Land Use Application #749117 - Brown Bear - New Car Wash

PROJECT NARRATIVE

Site Development Permit - Brown Bear Car Wash

PRELIMINARY SITE PLAN

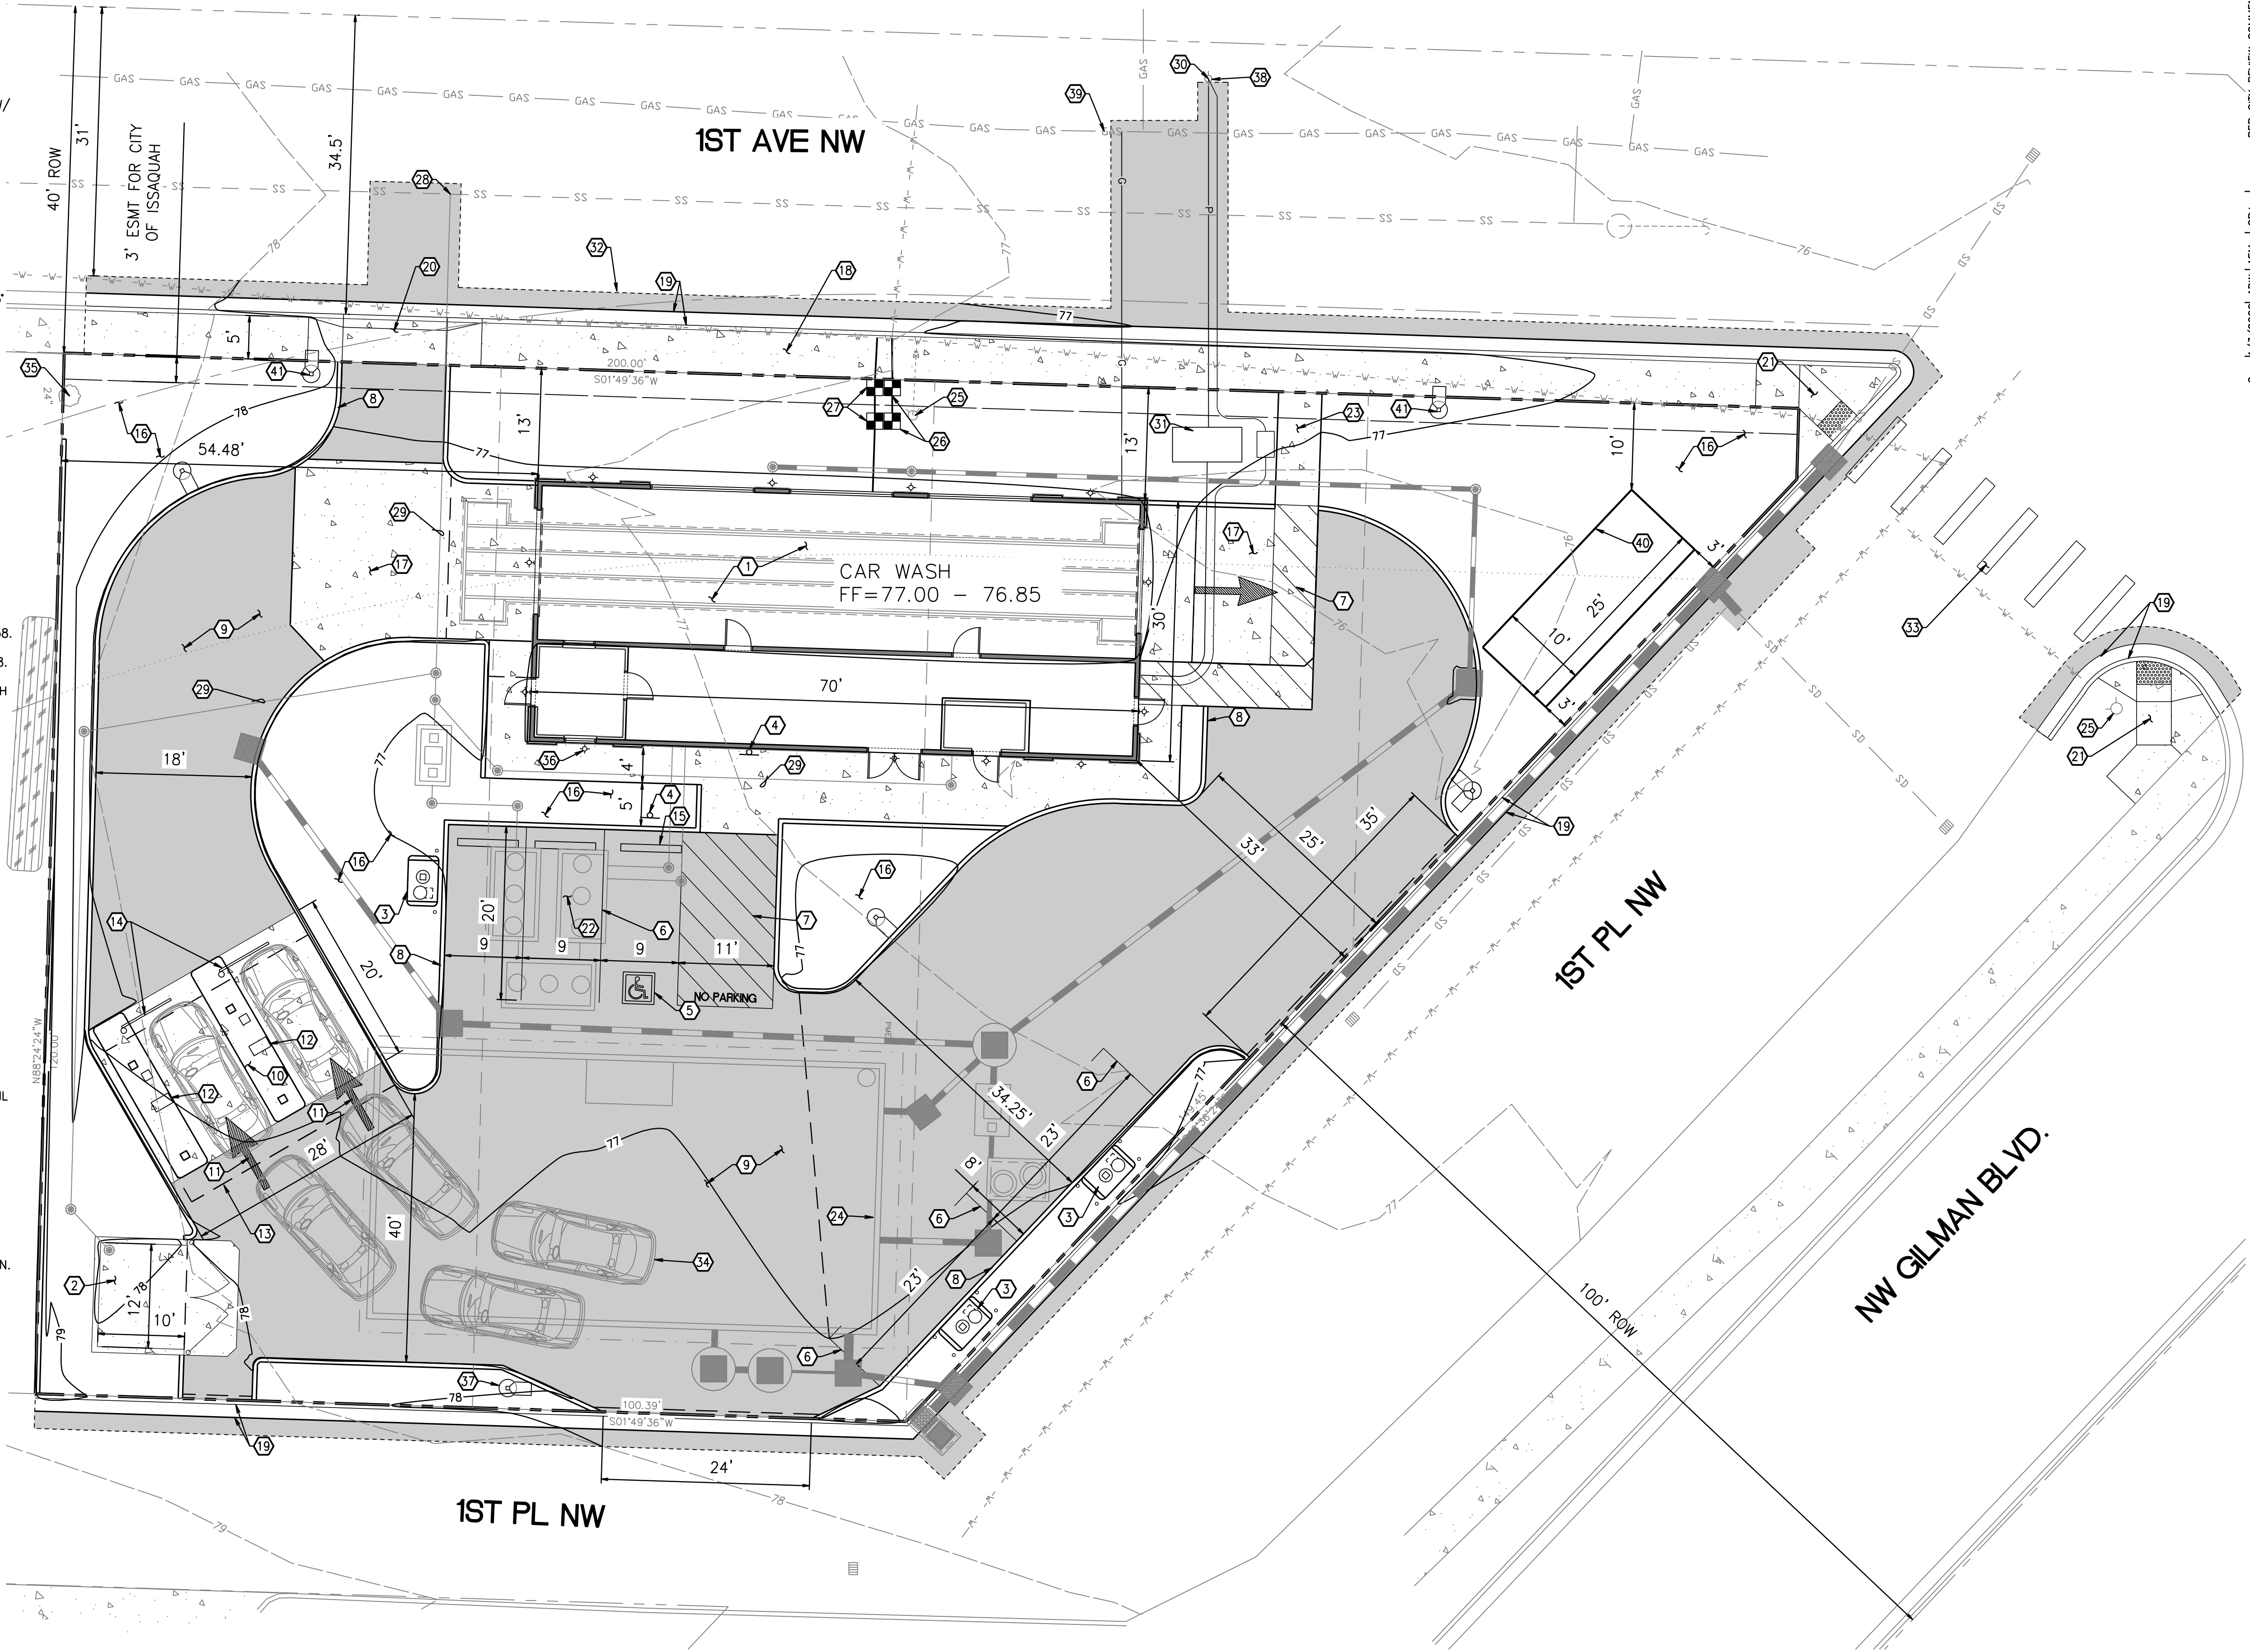
5. *Per IMC 18.09.050, a car wash must provide a minimum of six (6) stacking spaces per drive-through plus 1 parking stall per employee at maximum shift. Vehicle stacking will be measured from the auto sentry canopy.*

Response: Please see the enclosed Preliminary Site Plan. The project provides eight (8) stacking spaces with two (2) of the stacking spaces located between the car wash entrance and the auto sentry canopy and six (6) stacking spaces provided collectively at or behind the auto sentry canopy. Additional stacking is available with the temporary closure of the southernmost driveway entrance during periods of high volumes that exceed typical demand.

PRELIMINARY PLANTING PLAN

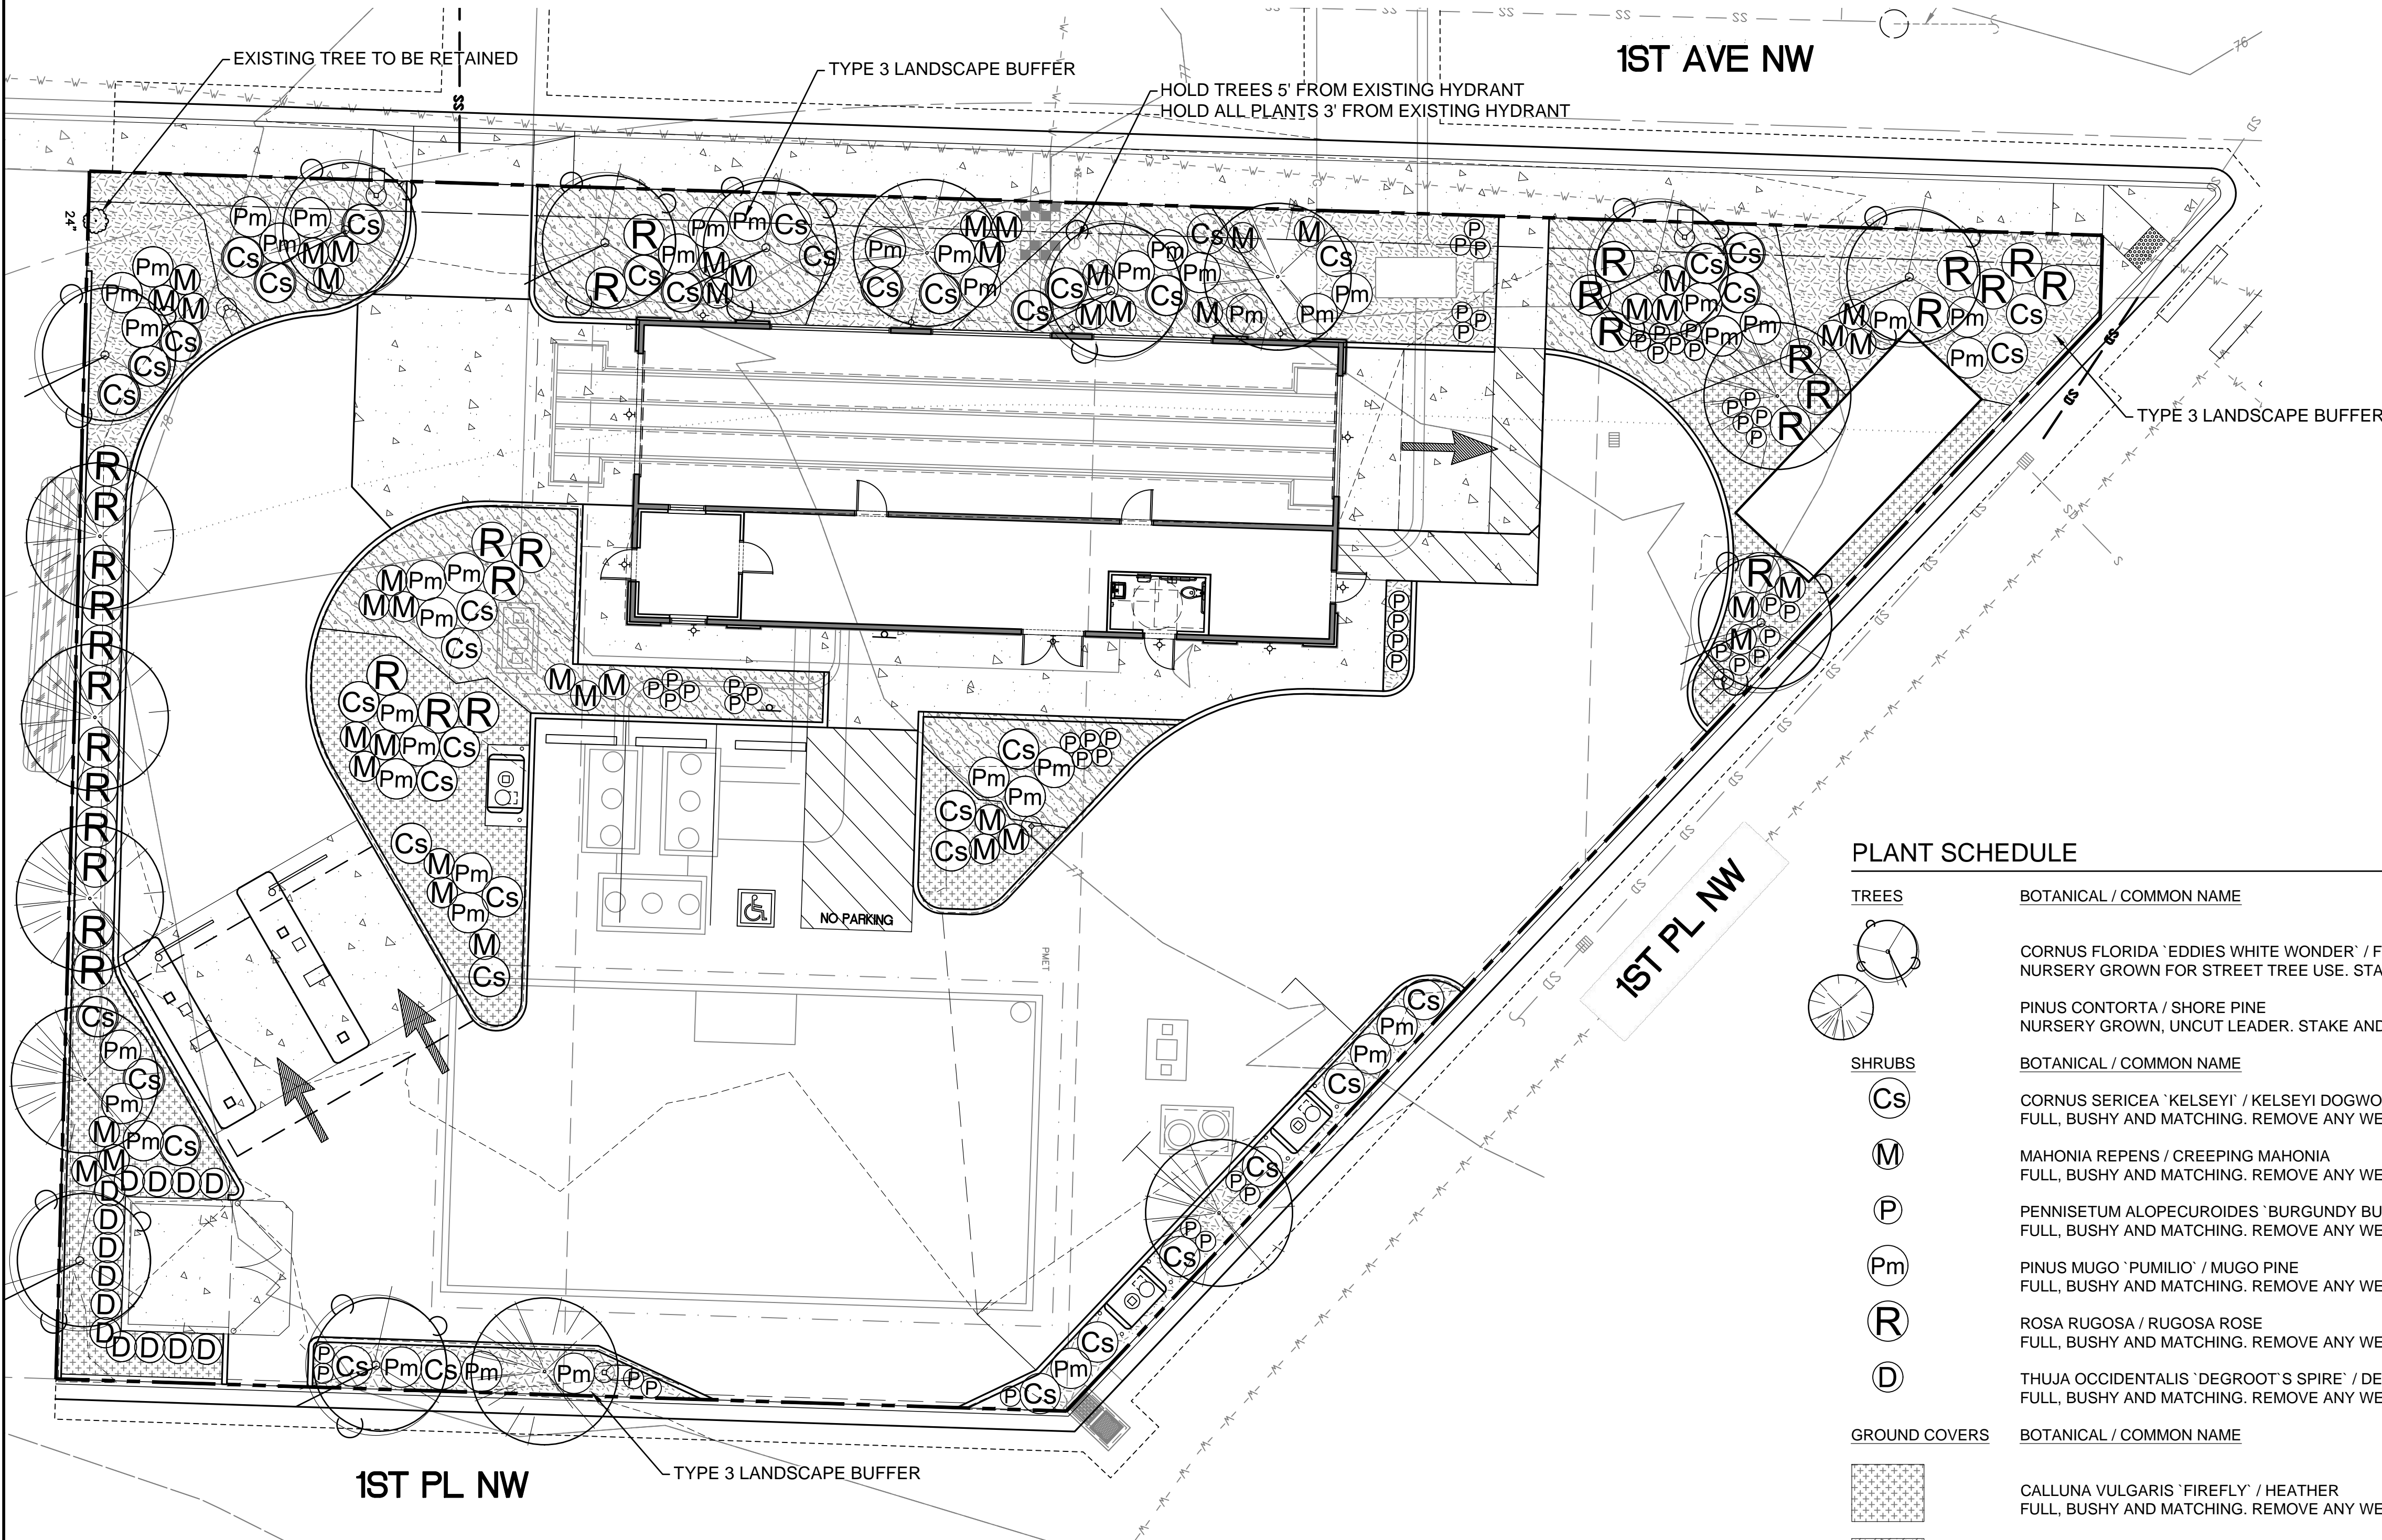
9. *Landscaping along the frontage and perimeter must be a Type 3 landscape. Please see IMC 18.12 for details. This will be reviewed during the land use process.*

Response: Please see the enclosed Preliminary Landscape Plan. Trees are provided along the perimeter and are planted every 20 feet on center and shrubs are planted in accordance with Table 18.12.070(B)(3). Perimeter landscaping is provided as required along 1st Avenue NW.
